<b>Reference:</b>	21/00396/AMDT	
<b>Ward:</b>	Chalkwell	
<b>Proposal:</b>	Erect first floor extension with bay window to front to form additional floor to existing dwelling, recessed balcony to front, dormers and rooflights to side elevations to form habitable accommodation in roof and alter elevations (variation of plans approved under condition 2, variation of materials under condition 3 and variation of obscure glazing requirement under condition 5 attached to permission reference no. 20/01834/FULH dated 23/12/2020)	
<b>Address:</b>	25 Mount Avenue Westcliff-On-Sea Essex SS0 8PS	
<b>Applicant:</b>	Mrs McCormick	
<b>Agent:</b>	Mr Robert Parish	
<b>Consultation Expiry:</b>	24/05/2021	
<b>Expiry Date:</b>	04/06/2021	
<b>Case Officer:</b>	Oliver Hart	
<b>Plan Nos:</b>	20-051-pp-01 ISS02; 20-051-pp-02 ISS09; 20-051-pp-03 ISS08	
<b>Recommendation:</b>	<b>GRANT PLANNING PERMISSION</b> subject to conditions

Figure 2: Current development proposal

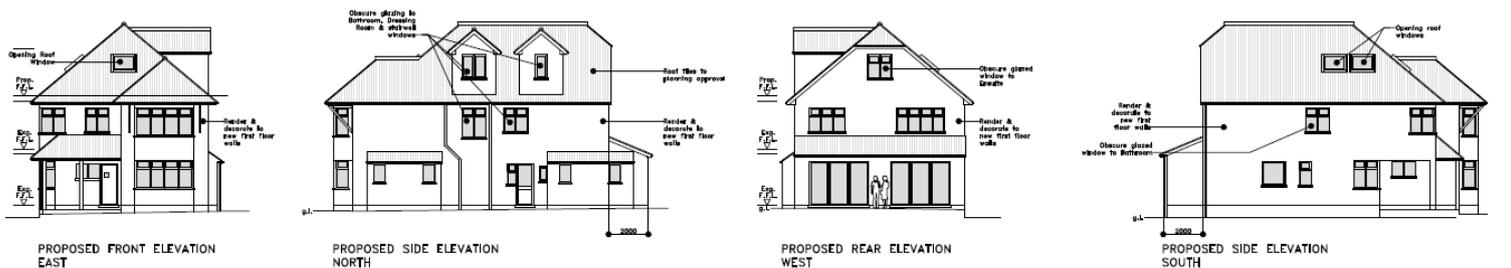
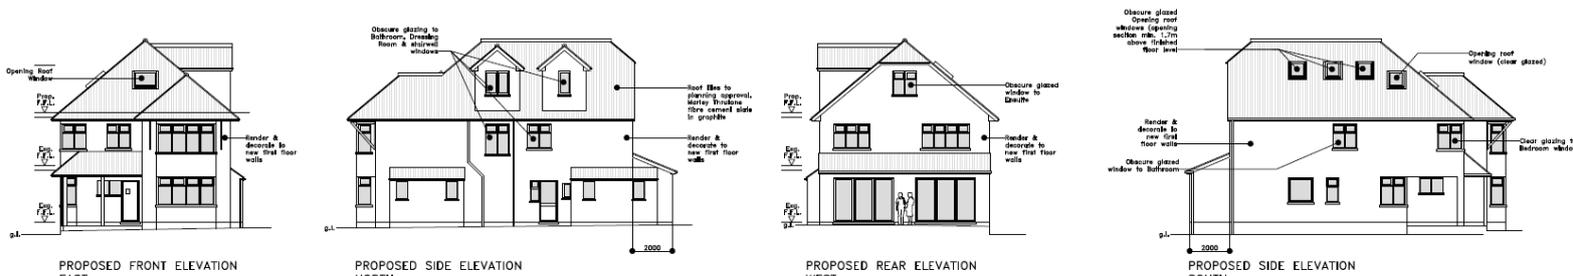
- The re-arrangement of existing rooflights to the southern flank roofslope and addition of 2no. further rooflights to the southern flank roofslope (4no. in total).
- Incorporation of a slate roof tile.
- Removal of the requirement for a first-floor corner window within the southern flank elevation to be glazed with obscure glass.

- 7.5 The proposed amendments relate to the re-arrangement and addition of 2no. new rooflights to the southern flank roof slope (4no. in total), altering the proposed roof tile from a matching tile to a slate (grey) tile and removing the requirement for obscured glazing to the first-floor corner window within the southern flank elevation.

- 7.6 Having regard to the mixed nature of development in Mount Avenue, no objection is raised with regard to the provision of additional rooflights to the southern flank elevation, the proposed slate roof tiles nor the removal of the requirement for obscure glazed windows to the first-floor corner window within the southern flank elevation given their minor and inconsequential visual impact.

- 7.16 With regards to the additional rooflights, the previous application was approved with 2no. rooflights to the southern flank roofslope. No objections were previously raised on account of their angle and elevated position such that they would not give rise to views of neighbouring private amenity space. As such, no objection is raised to the new arrangement of (4no.) rooflights to the southern flank roof slope given their elevated positions in the roof slope and angled views towards neighbouring roofs and the sky. The development is considered acceptable and policy compliant in this regard.

- 4 **Other than the first floor front bedroom corner wrap around window to the southern flank elevation of the application dwelling, the additional first floor**

windows to both flank elevations shall only be glazed in obscured glass (the glass to be obscure to at least Level 4 on the Pilkington Levels of Privacy) and fixed shut to a height not less than 1.7m above finished internal floor level except for any top hung fanlight the lowest part of which shall be not less than 1.7m above the adjacent finished internal floor level and shall be retained as such in perpetuity.
